Addendum No. 1

Re: Part B - James M. Seals, JR. Park – Athletic Restroom/ Concession and Field Improvements
504 Texas Street, Mobile, AL 36603
Project No. PR-041-20
Part C - Hackmeyer Park – Improvements Phase 2
3810 Conway Drive South, Mobile, AL 36608
Project No. PR-034-21

Date: November 14, 2022

C DTL PLAN - BENCH IN DOG YARD

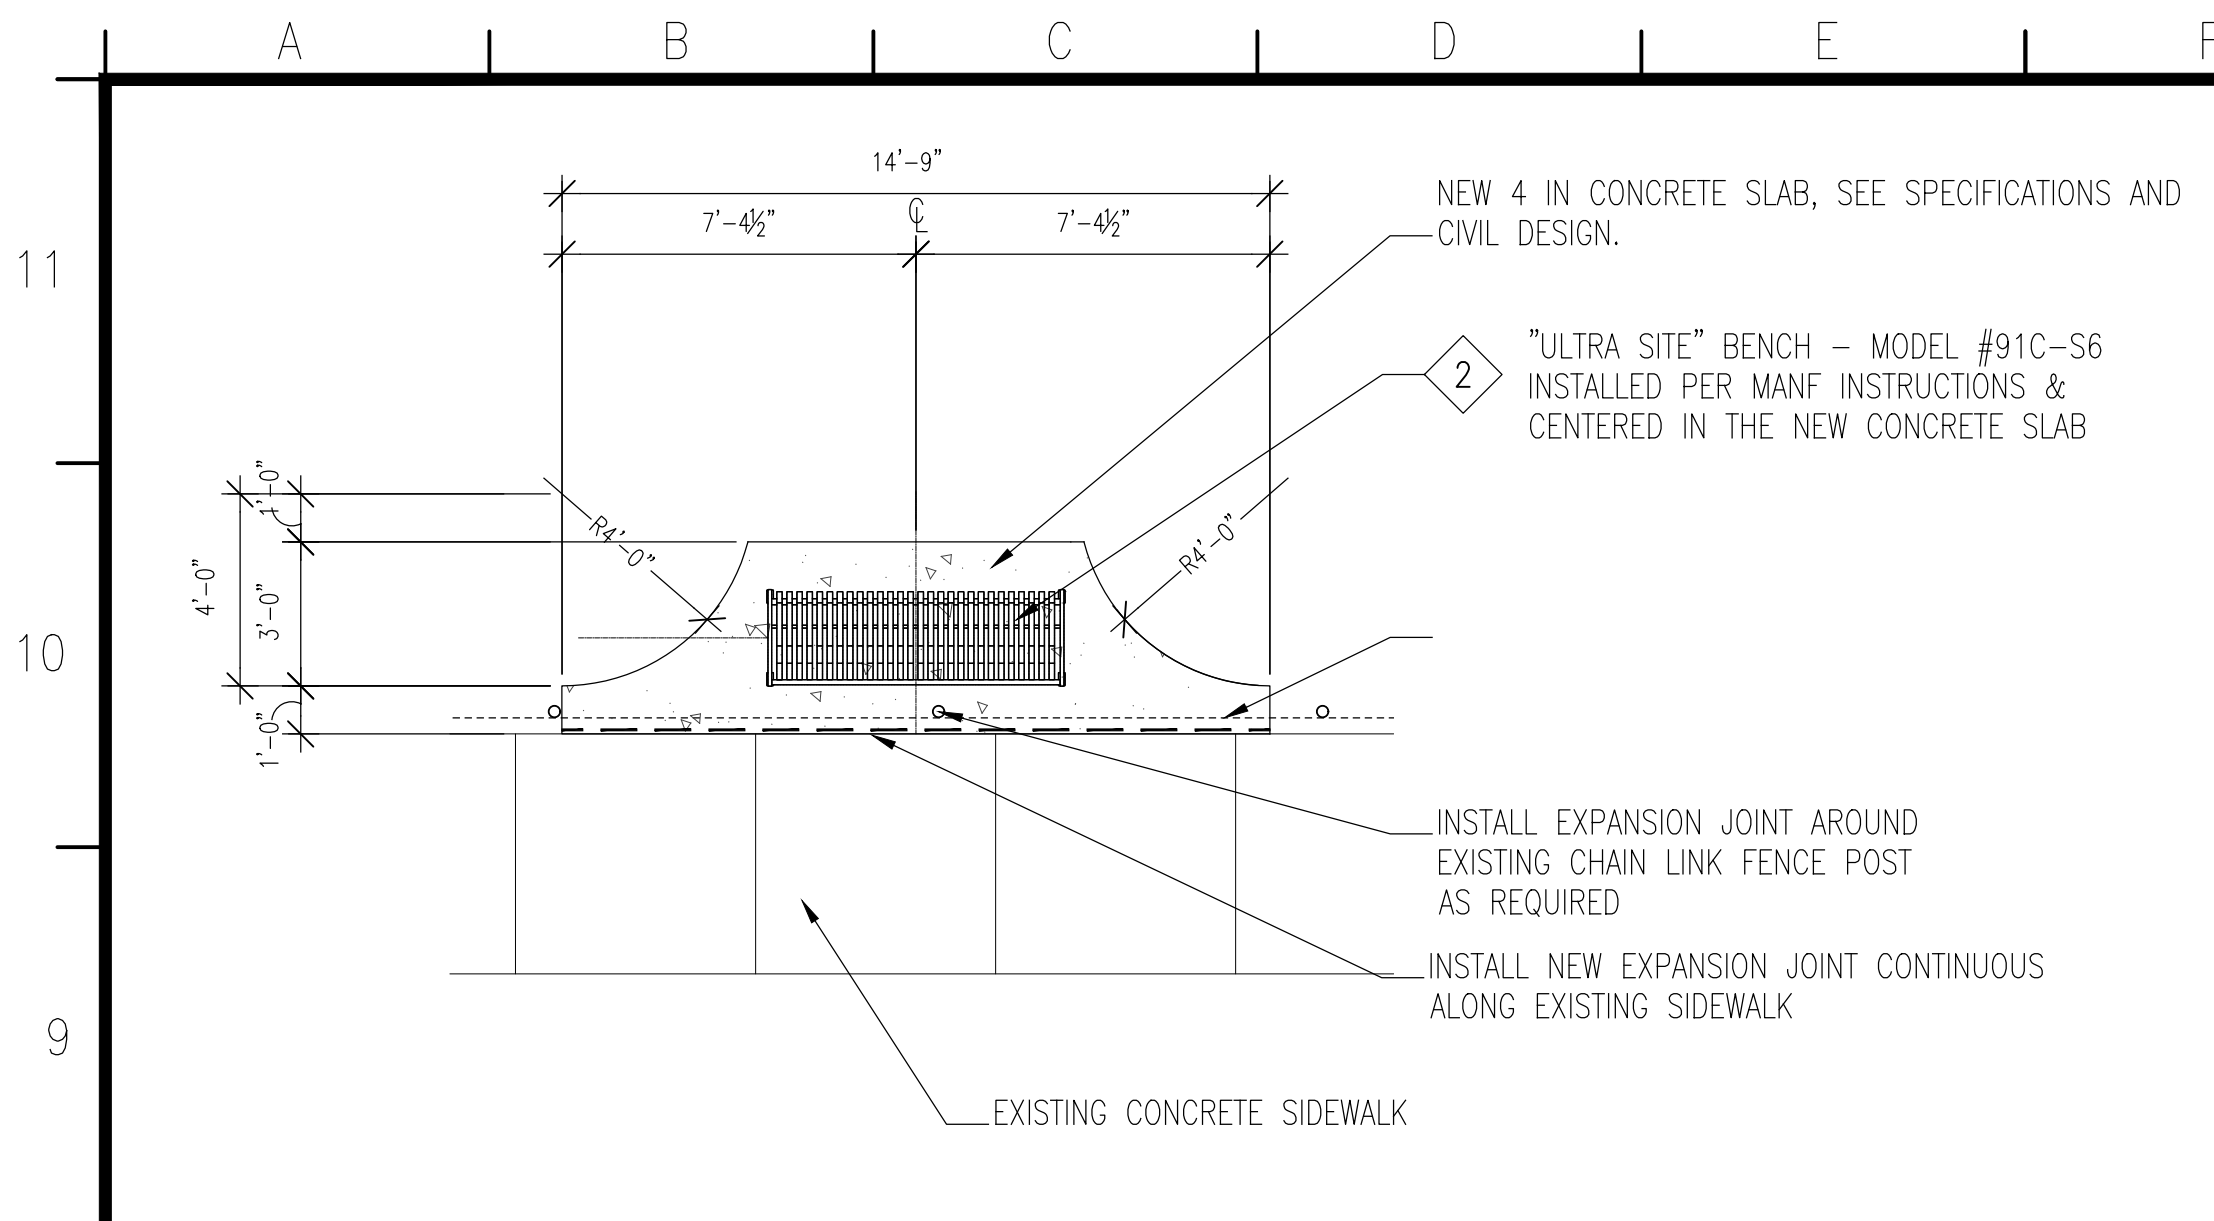
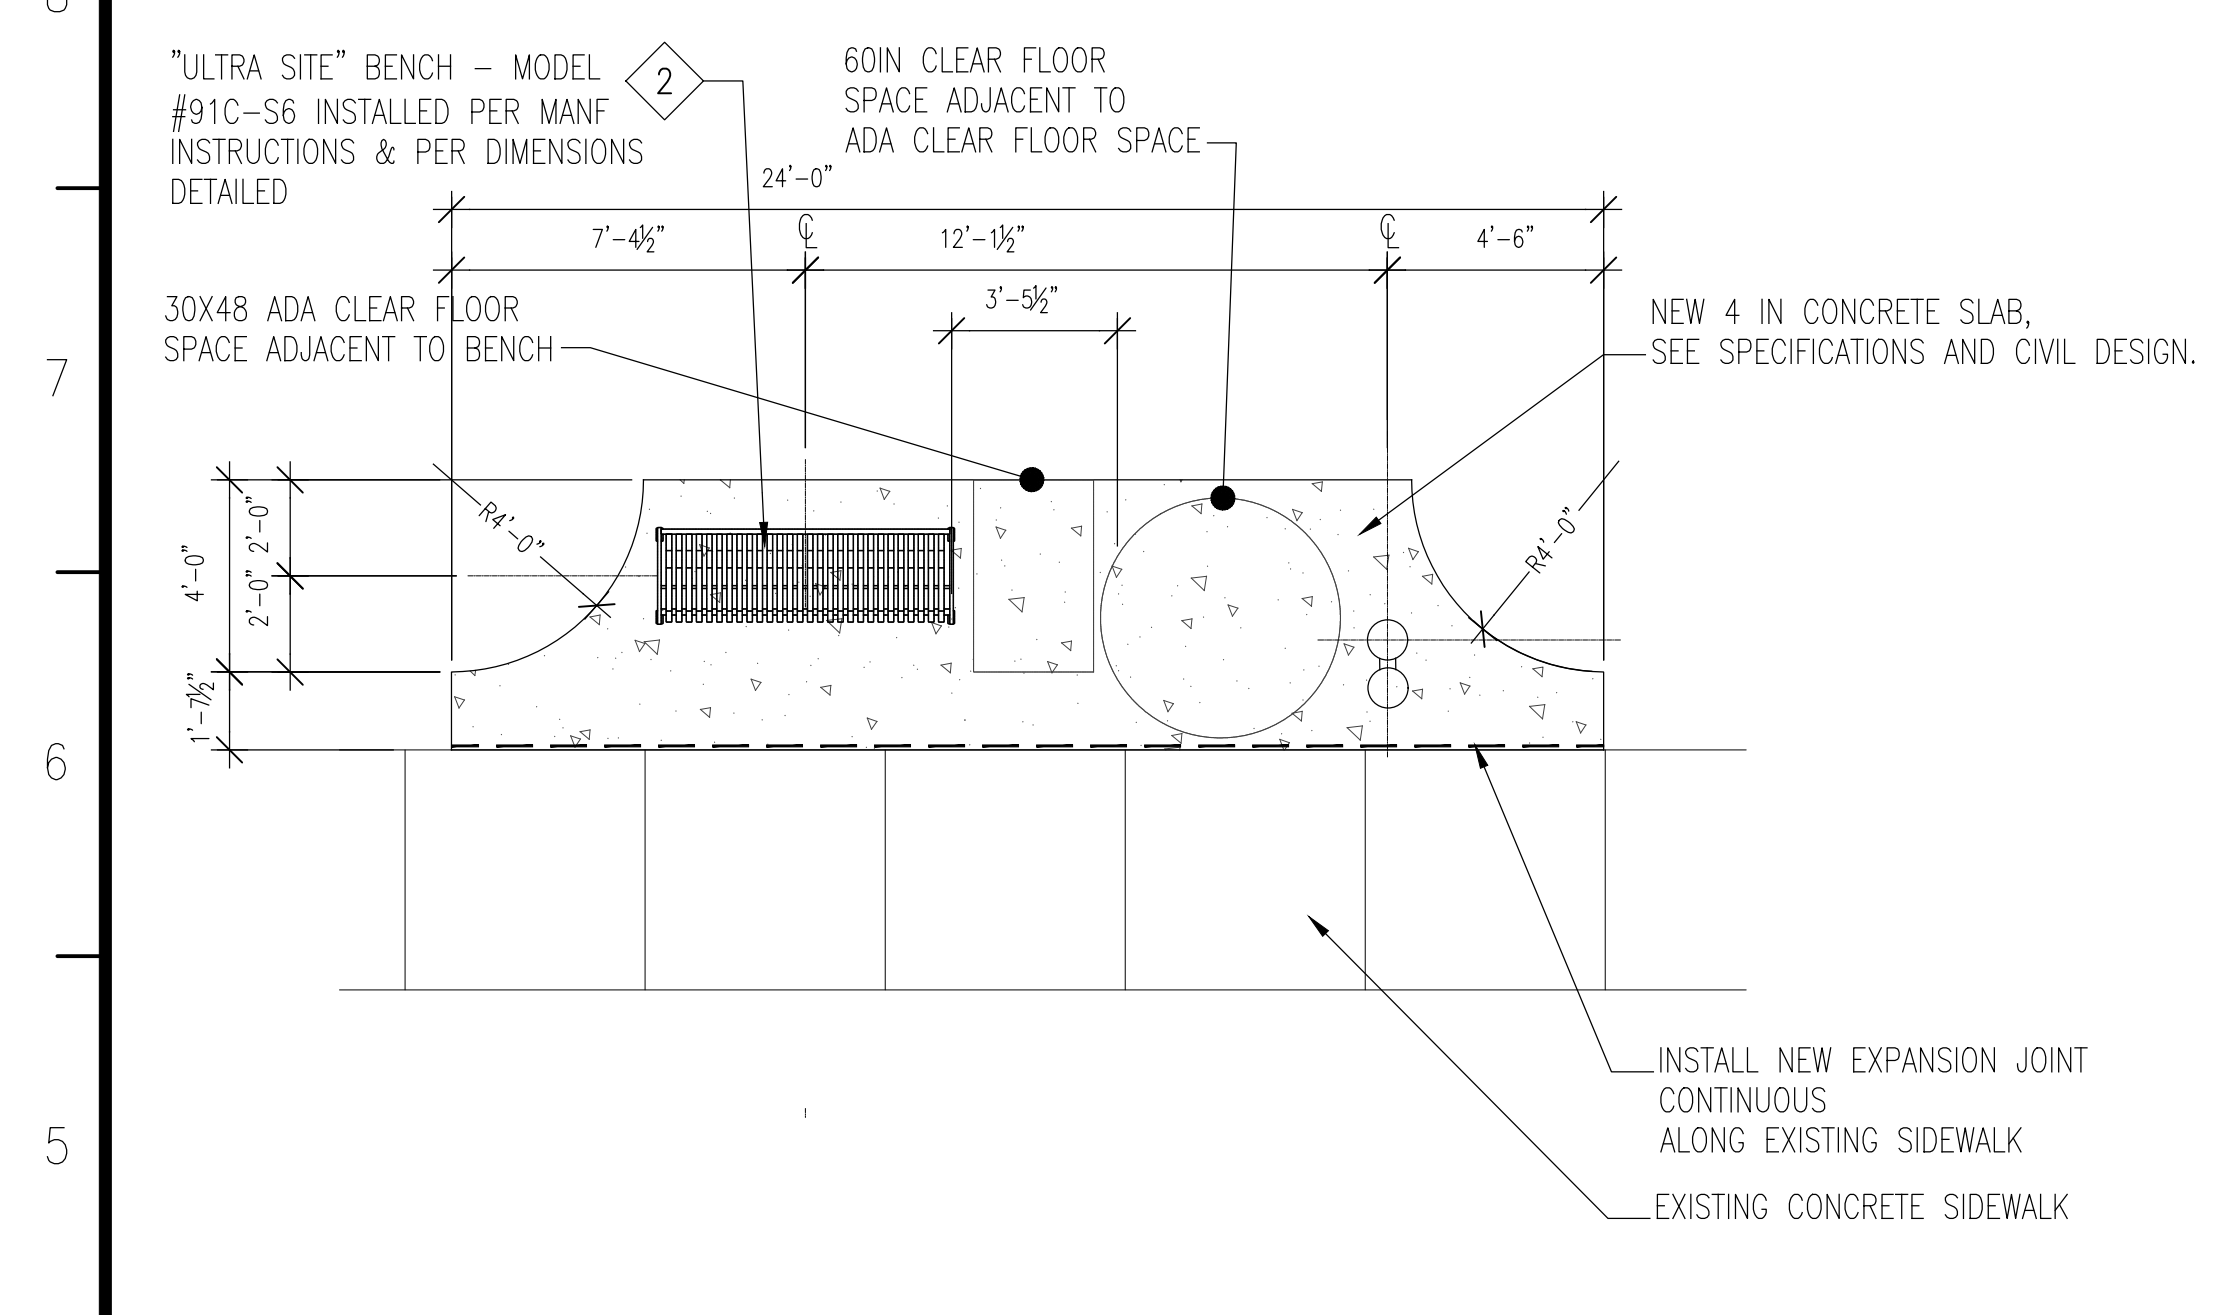
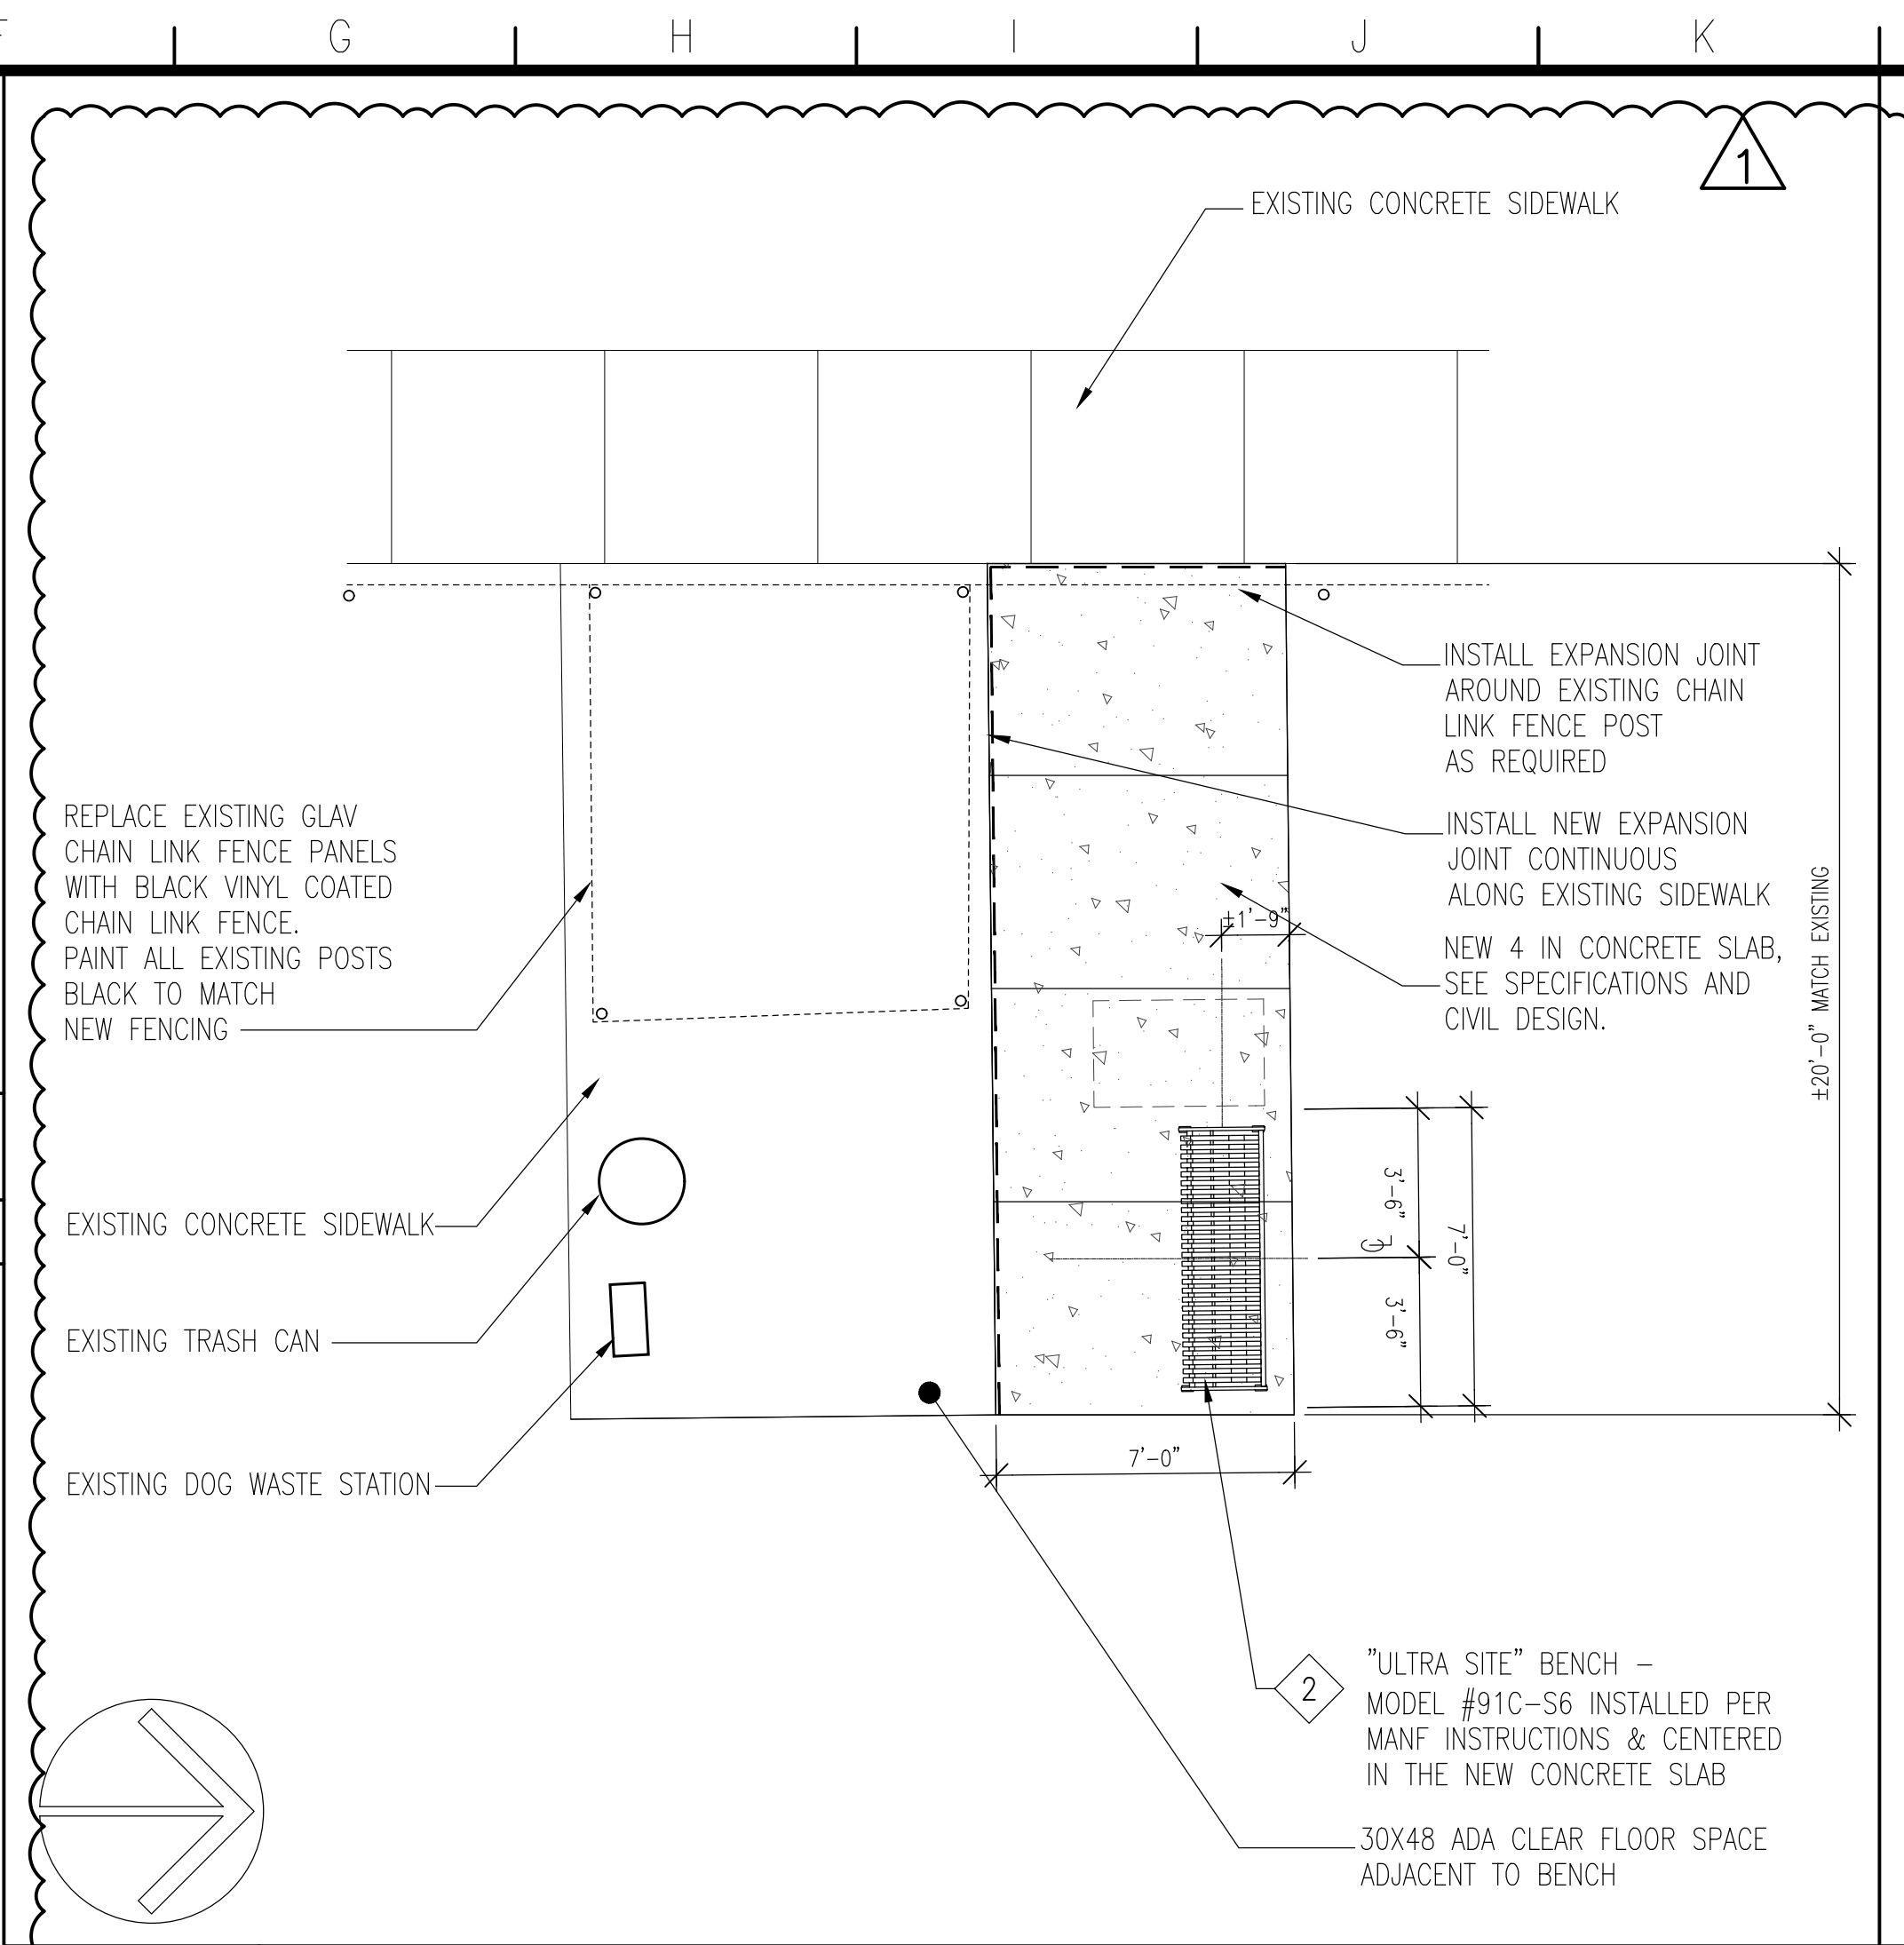
- Item 4: Sheet A1.3 Details – Park Furnishings
Replace this sheet dated 11.02.22 with the attached revised sheet of same title A1.3, dated November 07, 2022 and labeled Revision 01 (Addendum No. 1). Substantial changes include the following:
Revise Detail D/A1.3 to relocate doggie drinking fountain & bench.
